JRPP No:	2010SYW039
DA No:	527/2010
PROPOSED DEVELOPMENT:	Demolition, tree removal and the construction of a staged 3 storey residential flat building complex containing 106 apartments over basement car parking. Approval is also sought to use a portion of the building for community artist's space.
PROPERTY:	9 Albert Street, (Cnr O Connell Street) NORTH PARRAMATTA
APPLICANT:	DEM Pty Ltd on behalf of Housing NSW
OWNER:	New South Wales Land and Housing Corporation
REPORT BY:	Sara Smith

Assessment Report and Recommendation

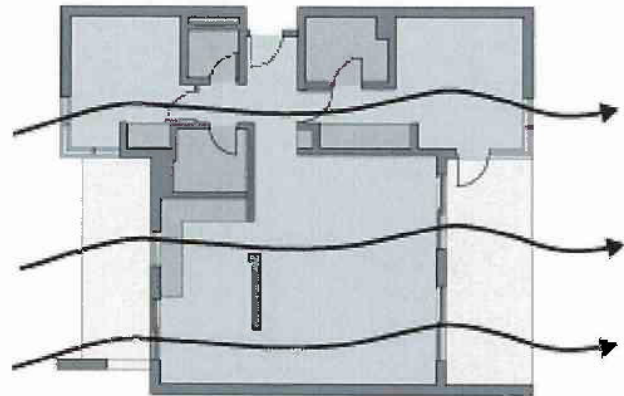
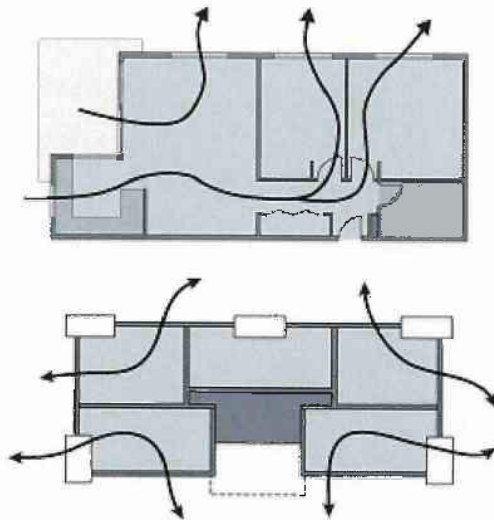
Panel Comments - Item 1. The panel is concerned in regards to assumptions made by the applicant to achieve Sepp65/RFDC cross ventilation requirements. The scheme proposes that internal central corridors are fully open in order to provide cross ventilation to a number of single aspect apartments via a Bedroom window opening onto the common corridor space.

The building forms and footprints have been carefully arranged to consider topography, maximising solar access to apartments and cross ventilation, and minimising overshadowing to open spaces. The open plan layout of the units is designed such that the balconies and private open spaces are an extension of the living spaces, therefore creating a seamless relationship between the indoor and outdoor living areas.

All individual units achieve a building depth range from 7.8 - 9.2m from the back wall of the kitchen to an external window in the living room; the efficient internal layout of the units enables good cross ventilation of the dwelling.
